TVA-BFN-TS-318

**BROWNS FERRY NUCLEAR PLANT (BFN) - UNITS 1, 2, AND 3 -
TECHNICAL SPECIFICATION (TS) NO. 318 - ANALOG
TRANSMITTER/TRIP SYSTEM, LEVEL : REACTOR WATER LEVEL
SETPOINTS, AND VARIOUS CALIBRATION FREQUENCIES**

PROPOSED TECHNICAL SPECIFICATION (TS) CHANGE TS-318
DESCRIPTION AND EVALUATION OF THE PROPOSED CHANGE

FIGURE 3
ENVIRONMENTAL INTERFACE - SEISMIC RESPONSE

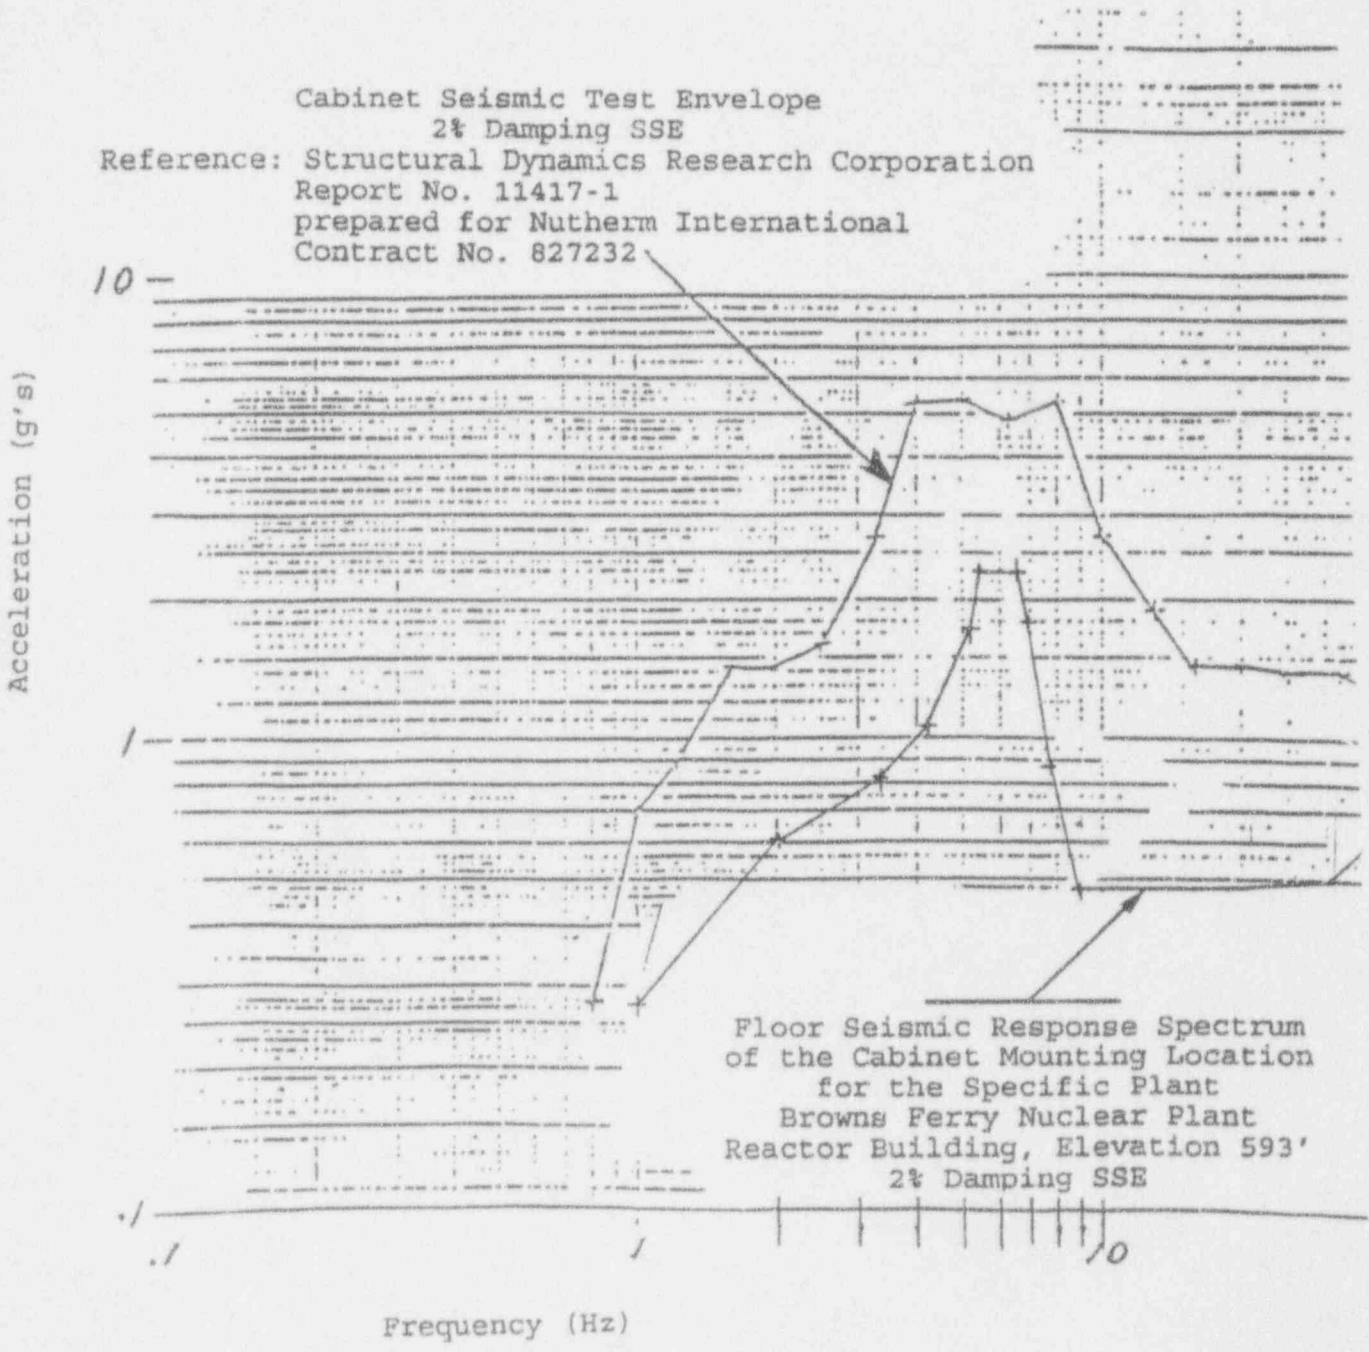
2. Comparison of the floor seismic response spectra of the cabinet mounting location for the specific plant to seismic test envelope that the cabinet was tested to.

2. Figure 3 provides the comparison of the floor seismic response spectra of the cabinet mounting location to the seismic test envelope that the cabinet was tested to.
